Access Compliance Report Public Rights-of-Way (Curb Ramps)

Main Street: HAZARD_AVE Cross Street: MONROE_ST Location: NW

ADA ID: RPRK211004140825 Ramp Type: Type 1 - Perpendicular Diagonal Initial Pass/Fail: Fail Overall Compliance: No Severity Score: 16

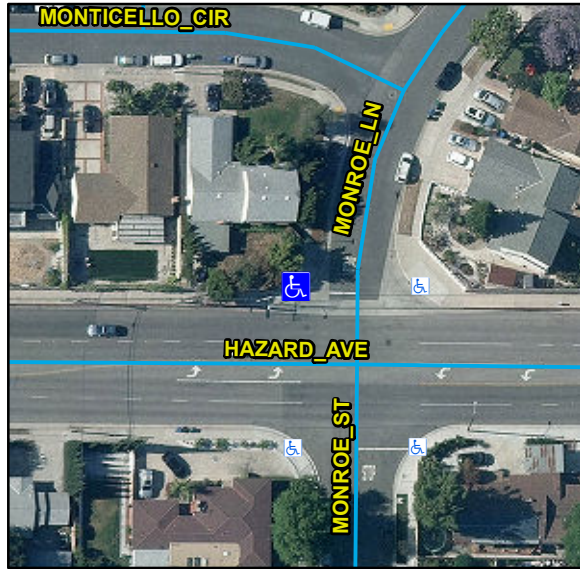
R304.2.2, R304.5.3, STD 1115

Remove & Replace Curb Ramp With Two New Directional Ramps or Equivalent.
